Access Compliance Report

Public Rights-of-Way

Intersection ID: 10023686	Main Street: COCA-COLA_PLAZA	Cross Street: N/A	Location: NW
ADA ID: 297DB20CB8D2	Ramp Type: Perp	Initial Pass/Fail: Fail	Overall Compliance: No
		Severity Score: 37.5

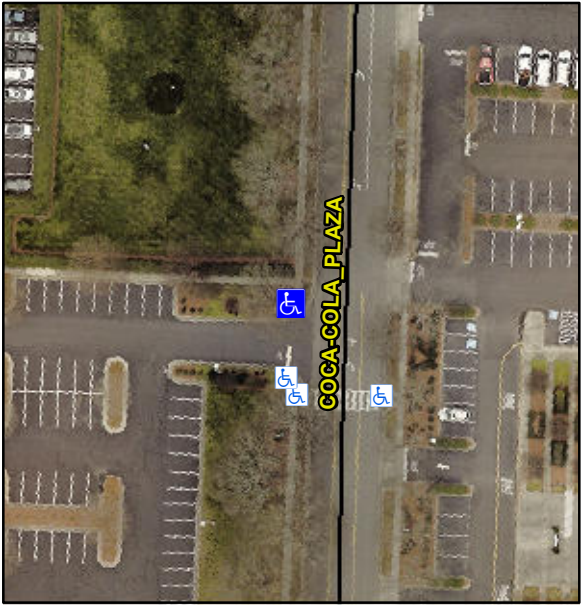
Codes/Mitigation Info/Possible Solution			Field Measurements/Component Compliance		
	Possible Solutions:		Compliance	Description	Data
	Remove & Replace Entire Ramp.		No	Ramp Length (in)	65.0
			Yes	Ramp Width (in)	48.0
			N/A	Flare Type LT	N/A
			N/A	Flare Slope LT (%)	N/A
			N/A	Flare Traversable LT?	N/A
			N/A	Landing Length (in)	N/A
			N/A	Landing Width (in)	N/A
			N/A	Landing Slope (%)	N/A
			N/A	Landing X Slope (%)	N/A
<p>Surveyor Notes:</p> <p>N/A</p> <p>PROW/ADA:</p> <p>R304.2.2, R304.5.3</p>			N/A	Flare Type RT	N/A
			N/A	Flare Slope RT (%)	N/A
			N/A	Flare Traversable RT?	N/A
			N/A	DWS Provided?	N/A
			N/A	DWS Contrast?	N/A
			N/A	DWS Length (in)	N/A
			N/A	DWS Full Width?	N/A
			N/A	DWS Offset (in)	N/A
			N/A	Shared Landing?	N/A
			N/A	Gutter Ponding?	N/A
<p>Street 1 Name</p> <p>Stop Condition-Street 2</p> <p>Street 2 Name</p> <p>Stop Condition-Street 1</p>			N/A	Gutter Lip Ht (in)	N/A
			No	Painted X Walk1?	N/A

X Walk 1 Direction	To S
			N/A	X Walk 1 Width (in)	N/A
				X Walk 1 Slope (%)	1.3
				X Walk 1 X Slope (%)	0.6
			N/A	Ramp inside XWalk1?	N/A
			N/A	Road Slope (%)	N/A
			N/A	Road X Slope (%)	N/A
			N/A	Any Obstructions?	N/A
<p>Total Cost:</p> <p>\$ 1850.00</p>			N/A	Obstruction Type	
			N/A	Clear Space?	N/A
			N/A	Clear Space to XWalk (in)	N/A
			N/A	Storm Grate/Utility Hazard?	N/A
				Storm Grate/Utility Type	
			N/A		N/A
			Yes	Surface Condition? (G/P)	Good
